WEST OF IFIELD PHASE 1 INFRASTRUCTURE

Stage 1 Road Safety Audit

Designers Responses Report

Document Ref: 10053900-ARC-HRR-ZZZ-TS-HE-00011

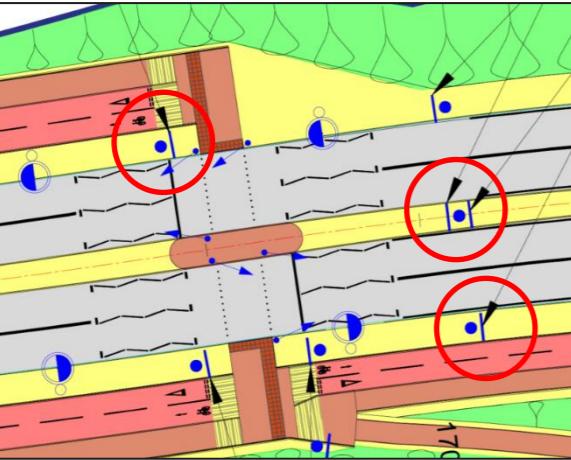
Reference	RSA1 Problem	RSA1 Recommendation	RSA1 Design Organisation Response	Overseeing Organisation Response	Agreed RSA Action
	<p>The position of manhole cover MH-39 appears to be located at or near the southern side road uncontrolled crossing RD_1A_S02 tactile paving (see insert). This may present a slip / trip hazard to those using the uncontrolled crossing facility particularly if the manhole cover is uneven, incorporates an upstand or is slippery underfoot. A similar situation occurs at the following locations:</p> <ul style="list-style-type: none"> • MH-73 RD_1A_P01 • MH-30 RD_1A_P01 • MH-53 RD_1A_P02 • MH-87 RD_1A_P02 • MH-143 RD_1A_P02 				
1A 3.3.7	<p>Location: E – RD_1A_P02 / Rusper Road crossing facility, West of Ifield Phase 1A (Drg. 10051123_ARC-050-1A-DR-CE-00009 Rev P06).</p> <p>Summary: Risk of crossing collisions. Walkers crossing at the junction are expected to cross the carriageway in one go or risk being stranded in the middle of the road where they may be struck by turning traffic. This may be a particular problem for those frail, mobility / sensory impaired crossing the wide carriageway, looking in multiple directions and avoiding large turning vehicles such as buses.</p> 	<p>The use of a refuge island at the junction bellmouth may allow crossing walkers to cross safely in two halves, whilst providing a safe space to wait and observe oncoming traffic.</p>	<p>Disagree with the RSA problem and recommendation.</p> <p>This junction is intended solely for infrequent bus use and private access, with no through route. As a result, incorporating a refuge island would be excessive given the limited vehicle activity at the junction. Additionally, the area is constrained by the available land, and the crossing length is less than 10 meters.</p>
